# Access Compliance Report

## Public Rights-of-Way

### (Curb Ramps)

Intersection ID: 51794	Main Street: SUTTONVIEW_DR	Cross Street: BRADY_DR	Location: NW
ADA ID: C30C6E3FF8F6	Ramp Type: Perp	Initial Pass/Fail: Fail	Overall Compliance: No
			Severity Score: 21.25

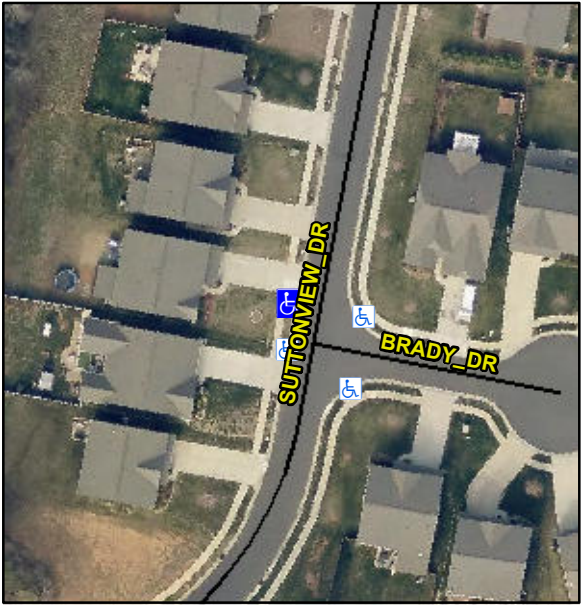
Codes/Mitigation Info/Possible Solution			Field Measurements/Component Compliance		
	Possible Solutions:		<b>Compliance</b>	<b>Description</b>	<b>Data</b>
	<b>Remove &amp; Replace Entire Ramp.</b>		<b>No</b>	Ramp Length (in)	47.0
			<b>No</b>	Ramp Width (in)	47.0
			<b>N/A</b>	Flare Type LT	N/A
			<b>N/A</b>	Flare Slope LT (%)	N/A
			<b>N/A</b>	Flare Traversable LT?	N/A
			<b>N/A</b>	Landing Length (in)	N/A
			<b>N/A</b>	Landing Width (in)	N/A
			<b>N/A</b>	Landing Slope (%)	N/A
			<b>N/A</b>	Landing X Slope (%)	N/A
<p>Surveyor Notes:</p> <p><b>N/A</b></p> <p>PROW/ADA:</p> <p><b>Not Found, R304.5.1, R304.2.2</b></p>			<b>N/A</b>	Flare Type RT	N/A
			<b>N/A</b>	Flare Slope RT (%)	N/A
			<b>N/A</b>	Flare Traversable RT?	N/A
			<b>N/A</b>	DWS Provided?	N/A
			<b>N/A</b>	DWS Contrast?	N/A
			<b>N/A</b>	DWS Length (in)	N/A
			<b>N/A</b>	DWS Full Width?	N/A
			<b>N/A</b>	DWS Offset (in)	N/A
			<b>N/A</b>	Gutter Ponding?	N/A

<b>N/A</b>	Gutter Lip Ht (in)	N/A
			<b>No</b>	Painted X Walk1?	N/A
				X Walk 1 Direction	To E
			<b>N/A</b>	X Walk 1 Width (in)	N/A
				X Walk 1 Slope (%)	2.4
				X Walk 1 X Slope (%)	1.2
			<b>N/A</b>	Ramp inside XWalk1?	N/A
			<b>N/A</b>	Road Slope (%)	N/A
			<b>N/A</b>	Road X Slope (%)	N/A
			<b>N/A</b>	Any Obstructions?	N/A
				Obstruction Type	
Total Cost:		\$ 1850.00	<b>N/A</b>	Storm Grate/Utility Hazard?	N/A
			<b>N/A</b>	Storm Grate/Utility Type	N/A
			<b>Yes</b>	Surface Condition? (G/P)	Good
